Tyrone Operations  
P.O. Box 571  
Tyrone, NM 88065

**Re: Response to Comments on the Closure/Closeout Plan,  
Tyrone Mine Emma Expansion Project, Revision 21-1, Permit No. GR010RE**

# DP-396 Water Management Plan

Figure 4: Proportion of NPAG and PAG material in the Emma Pit at closure (adapted from DBS&A 2021)

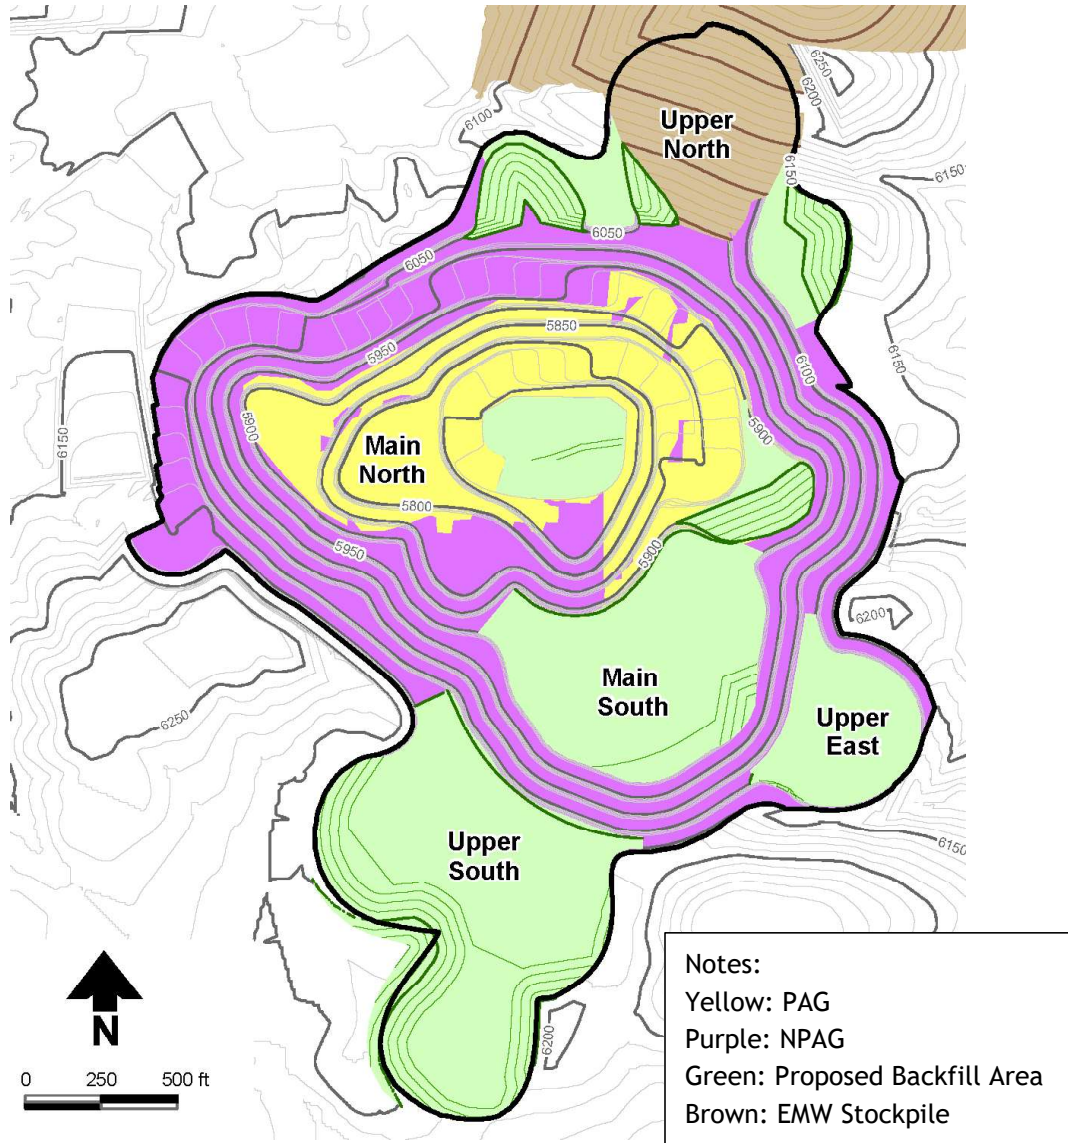
4. *Section 5.2.2, Planned Closure/Closeout Activities, page 26, discusses the planned reclamation activities within the Emma Pit. Drawing 004 in Appendix A-1 shows flat areas within the Main North Area that are not planned to have any cover material placed. Please provide a map depicting the predicted areas with PAG pit walls and benches at closure.*

Please see Figure 3-2 (page 91 of 676 in the pdf) of the CCP which shows the areas of the pit predicted to contain PAG. Tyrone has also attached here, Figure 4 from the *Water Quality Predictions for the Emma Pit: Emma Project* report included as Attachment IA-3, to the DP-396 Application dated October 22, 2021.
